Access Compliance Report Public Rights-of-Way (Curb Ramps)

Main Street: ESENCIA_DR		Cross Street: SUERTE_ST		Location:	N
ADA ID: RPRK211124140943	Ramp Type: Type 1 - Perpendicular	Initial Pass/Fail: Fail	Overall Compliance: No	Severity Score:	2
Codes/Mitigation Info/Possible Solution			Field Measurements/Component Compliance

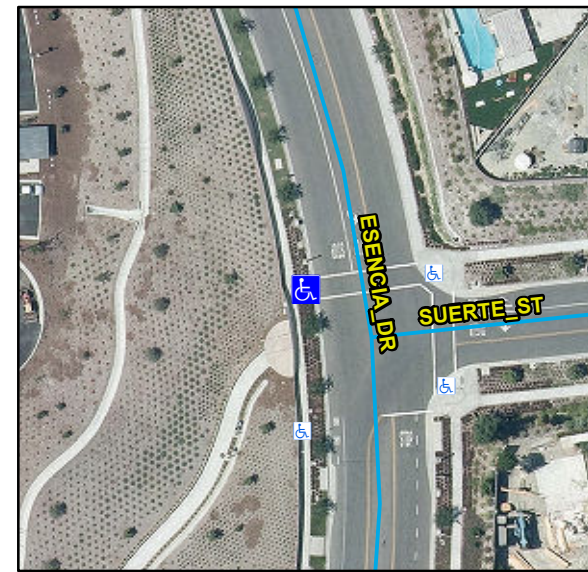
R304.5.3, STD 1115

Remove & Replace Entire Ramp.
